Kirtland Air Force Base is submitting an Addendum to the Light Non-Aqueous Phase Liquid (LNAPL) Containment Interim Measures Work Plan Part 1 - Characterization, Bulk Fuels Facility Spill, Solid Waste Management Units ST-106 and SS-111. The original LNAPL Containment Work Plan was submitted to you in July 2011.

LNAPL Containment Workplan Addendum for the Bulk Fuels Facility Spill, SWMUs SS-111 and ST-106

**Subject: LNAPL Containment Well Location and Installation  
LNAPL Containment Interim Measures Work Plan Part I - Characterization, Bulk  
Fuels Facility Spill, Solid Waste Management Units ST-106 and SS-111  
Addendum November 2011  
Albuquerque, New Mexico**

**FIGURE 1**

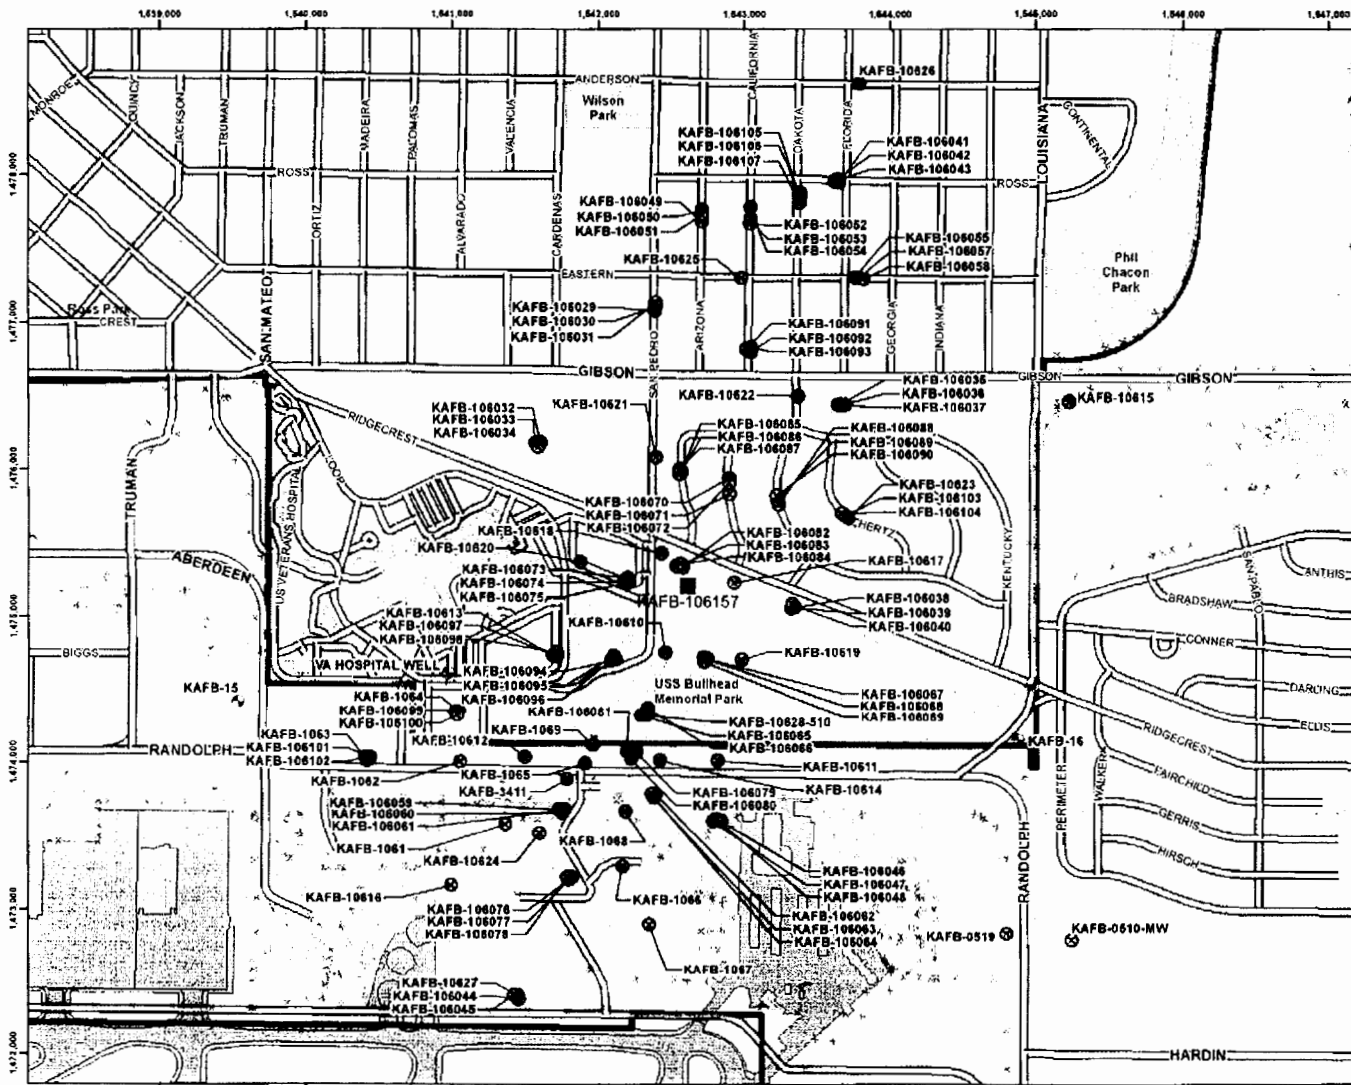
Shaw conducted a technical evaluation of the proposed containment well location and quantity as a result of discussing with the NMED Tiger Team on 3 November 2011. As a result of that evaluation, Shaw determined that a single containment well would be sufficient for containing the LNAPL, meeting the primary objective of the containment system and work plan. The proposed change is to move KAFB-106157 approximately 180 feet southeast of the original location (Figures 1 and 2). Figure 3 shows the predicted capture zone of this containment well, using the most recent hydrogeological data and recently acquired production well data for both Kirtland Air Force Base (AFB) wells and the Albuquerque Bernalillo County Water Utility Authority (ABCWUA) wells.

**Figure 4. Extraction Well Construction**

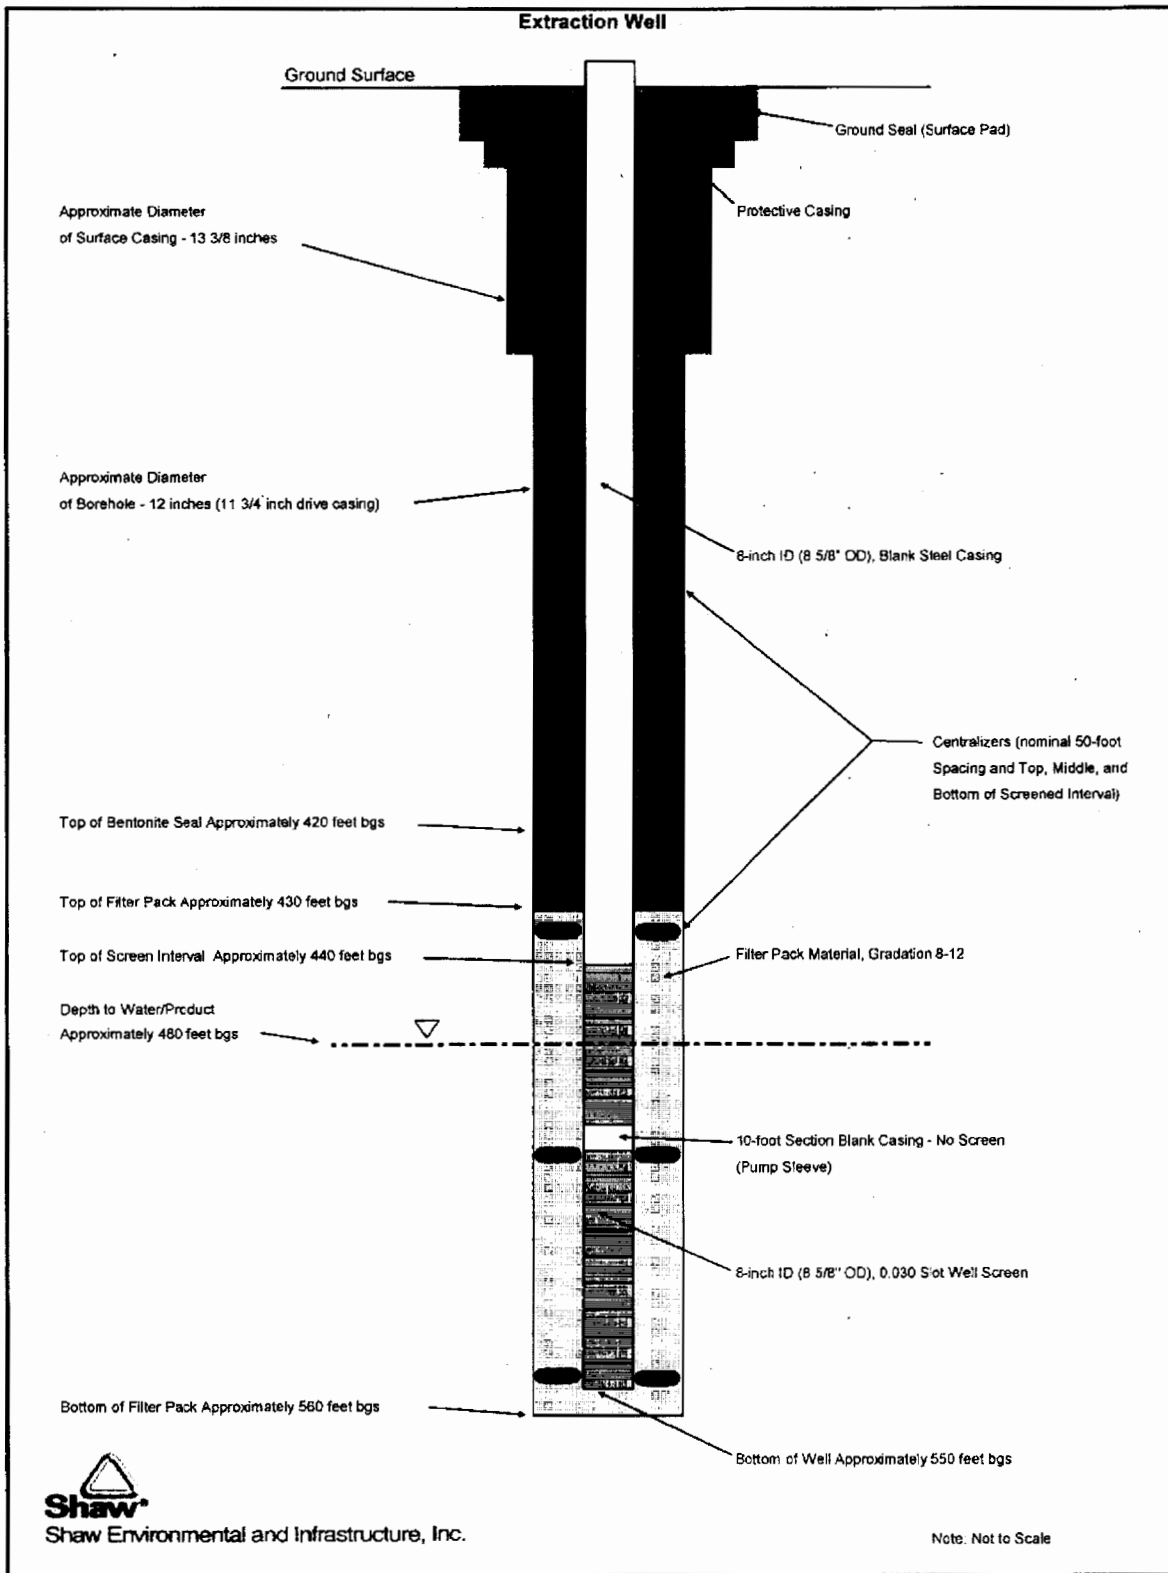
In order to accommodate the documented rise in water levels in the project area, the screening interval of the LNAPL containment well has been revised from what was proposed in the work plan. Figure 4 is a schematic diagram of the proposed well construction. Below is the proposed procedure and well design for the LNAPL containment well KAFB-106157:

- KAFB-106157 will be constructed with 90 feet of 8-inch diameter welded joint 0.030 slot stainless steel continuous wrap screen with double strong wires and rods, a 10-foot blank stainless steel pump sleeve section placed approximately 30 feet below the current water table, and a Schedule 40 carbon steel casing riser (Figure 2). The well will be constructed with 60 feet of screen/pump sleeve below the water table and 40 feet of screen above the water table to accommodate future water table rises. The steel well casing will extend approximately 2.5 feet above grade as a temporary completion during well development. The final depth of the pump sleeve will be decided in the field based on lithology encountered during drilling.

- An engineered 10-20 sand pack filter pack will be installed in the annular space between the well casing/screen and the borehole from the bottom of the borehole to approximately 10 foot above the top of the screened interval. The filter pack will be slurried with clean potable water and tremied into place to prevent bridging and to ensure continuous placement, while the drive casing is slowly removed. A 10-foot hydrated bentonite seal will be emplaced above the sand filter pack and incrementally hydrated with potable water in 1-foot lifts.

- After the last lift has hydrated for 2-hours, a cement grout with 6 percent bentonite and 2 percent calcium chloride by weight mixed at a weight density not less than 12.5 pounds per gallon will be

emplaced by tremie pipe to approximately 1.5 foot below the ground surface. The contractor will provide a mud balance and measure the grout weight density twice during placement to certify the grout specification.
